BCA Compliance Assessment Report

323-327 Warringah Road, Frenchs Forest

Light Industrial / Warehouse Development

Report no. J1087-BCA-2

Figure 2: Example of travel distance from ground level warehouses to open space

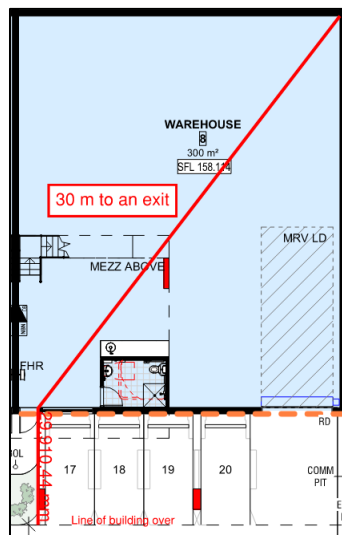
- > The travel distance to the single exit from all warehouses is up to 30 m in lieu of the maximum of 20 m, noting that an occupant has not reached the exit until they are in open space (out from under the cover of the building). Refer to Figure 2 below.

It is recommended that the excessive travel distances be addressed by a *performance solution*.

Figure 5: Recommended firewall separation at ground level

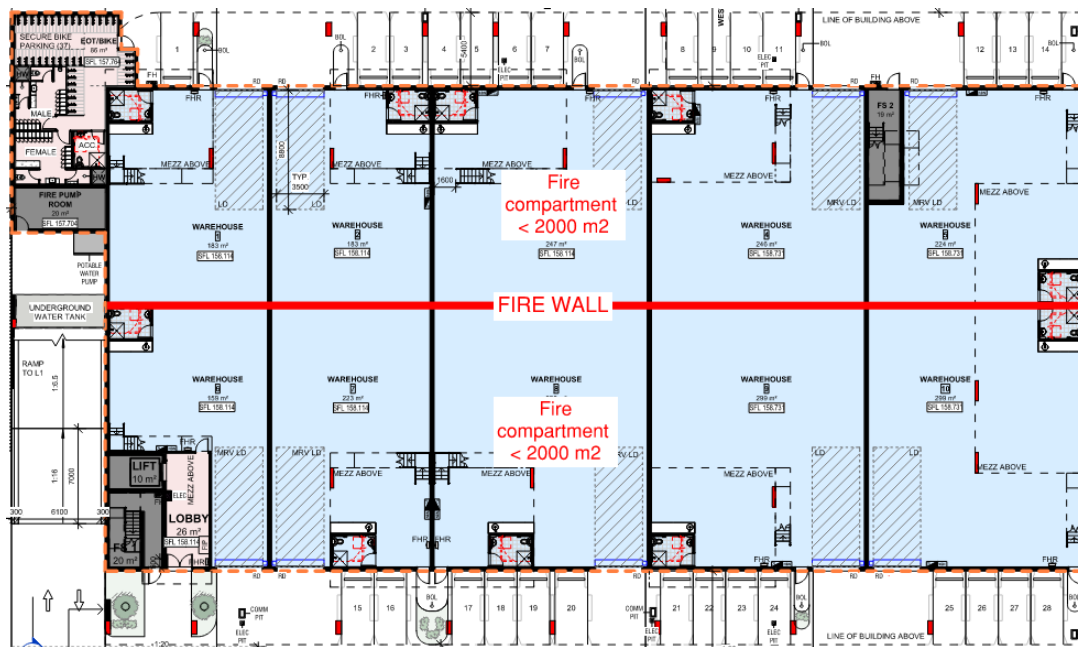
At the ground level of the building fire compartmentation less than the above limits is readily achievable by making the wall running north to south between the warehouses a *fire wall*, as shown in the figure below.

Figure 6: First floor level fire compartment > 2000m²

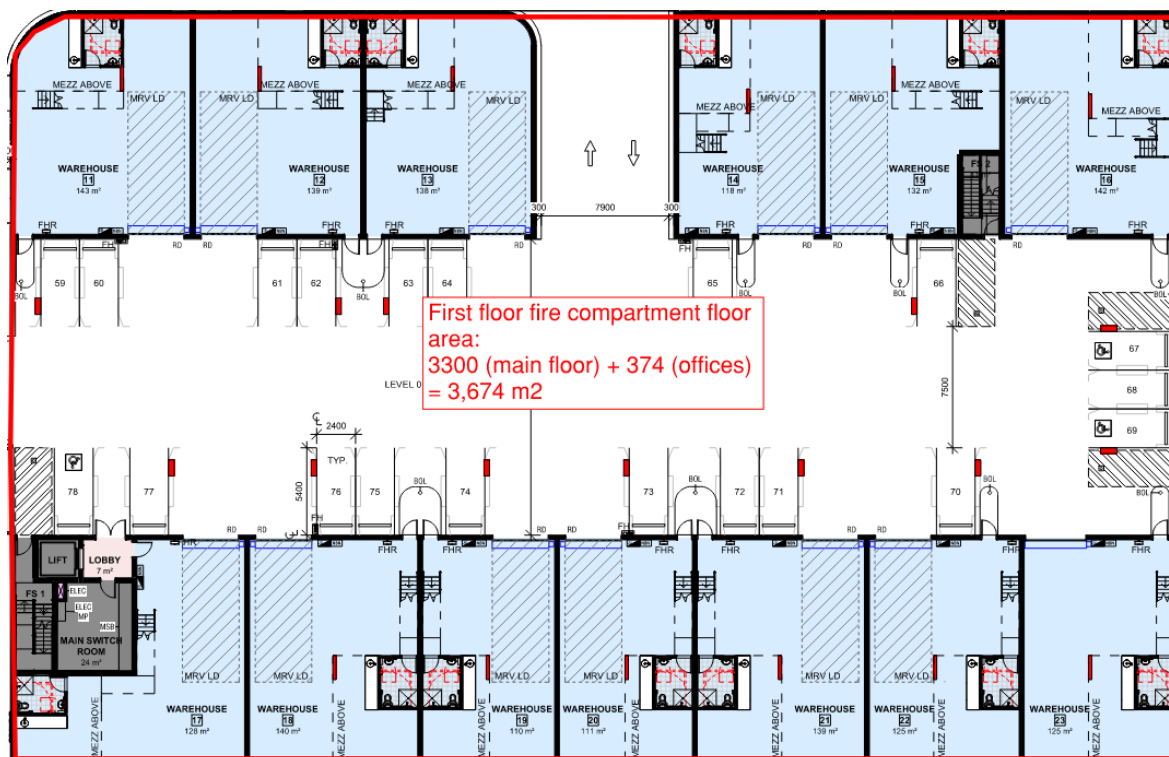
At first-floor level, the warehouses, mezzanine offices and undercover carpark form a single *fire compartment* that exceeds 2,000 m², due to the undercover carpark area (*open deck carpark*) not being excluded from the calculation of *fire compartment floor area*.

It is recommended that either sprinkler system be provided to these levels of the building in accordance with Clause E1.5, or that the design be discussed with a fire engineer (registered certifier – fire safety), to determine whether BCA compliance may be addressed via a *performance solution*, without the need for a sprinkler system.
